Facility: City Landfill

Address: 5700 Peabody Road Date of Survey: 07/01/11

Photo 1

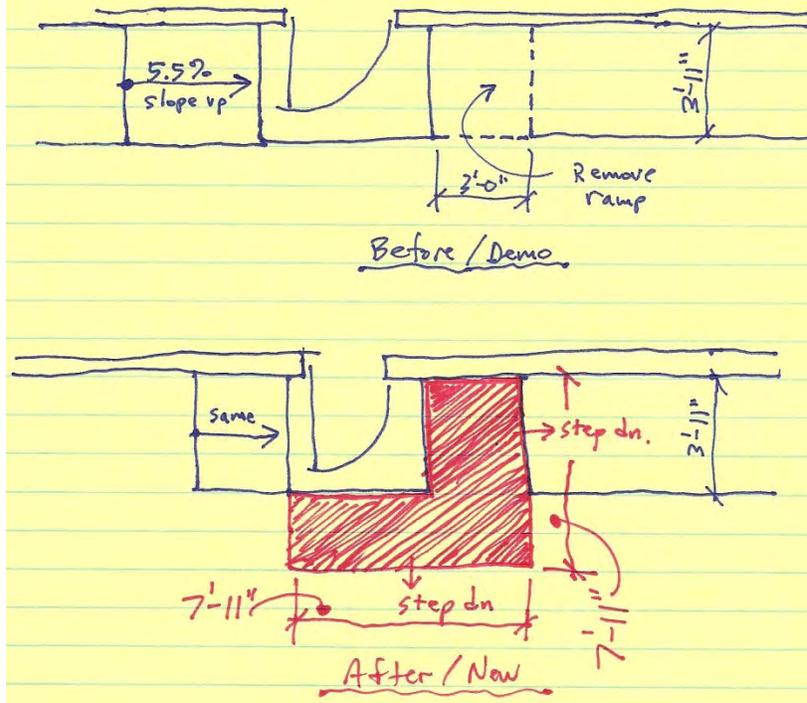
- Refer to building plan included with this report: (A) Increase the size of the existing level concrete landing (shown in blue ink in sketch on next page) at the south entry door into the Landfill Operation Center (see photo 1 below) to obtain the ADAAG required wheelchair clearances at the door with a larger landing (shown in red ink in the sketch on the next page).

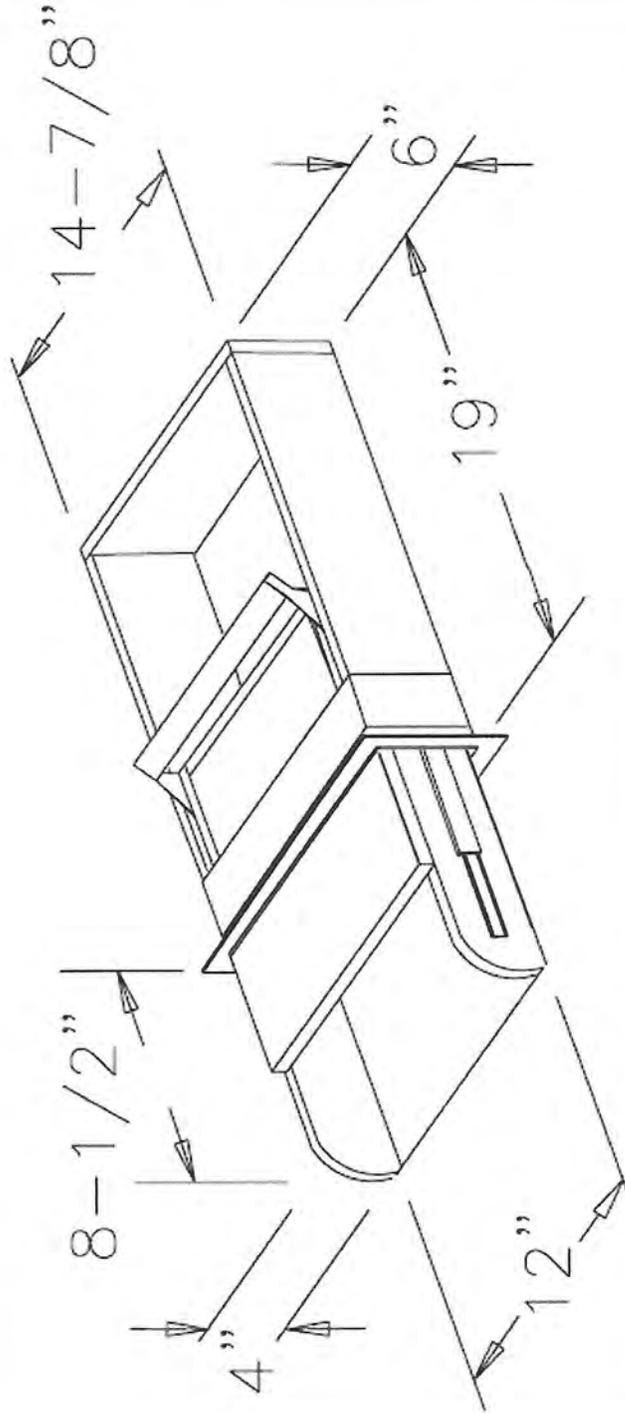
- Refer to building plan included with this report: (1) Existing ADA parking space slopes at the Landfill Operation Center are acceptable, but the space needs to be paint striped (blue paint) so that the parking spaces in min. 8' wide and the adjacent access aisle is min. 8' wide to allow for van access. Also add a van access sign to the existing ADA parking sign. **Estimated Cost: \$132.00**
- Refer to building plan included with this report: (2) Existing ADA parking space slopes at the Material Recovery Facility are up to 4% and spaces are not properly striped. Repave area for max. slopes of 2% and paint stripe (blue paint) the repaved spaces so that the one ADA parking space is min. 8' wide and the adjacent access aisle is min. 8' wide to allow for van access. Also add a van access sign to the existing ADA parking sign. **Estimated Cost: \$1,444.00**

- Refer to the building plan included with this report: (B) Install some type of sliding tray at the weigh station/pay booth for access from vehicles (see photo 2 below and example of sliding transaction tray included with this report).

- Refer to building plan included with this report: (C) Public-Use Unisex Restroom in the Landfill Operation Center: Move the bench in the corridor that blocks proper wheelchair clearance at the restroom door (see photo 3 below), install a braille/tactile ADA restroom sign on the latch side of the door and mounted to be 60” from floor to centerline of the sign, fur out wall with a half wall to get to 18” from the side wall to the centerline of the toilet fixture, replace the lavatory with a lavatory that meets the requirements of ADAAG 4.19, install a mirror with low reflective surface no higher than 40” a.f.f., relocate the paper towel dispenser so that it is wheelchair accessible and no higher than 48” a.f.f. and install rear and side grab bars to meet ADAAG 4.16.4. **Cost Estimate: \$3,574.00**
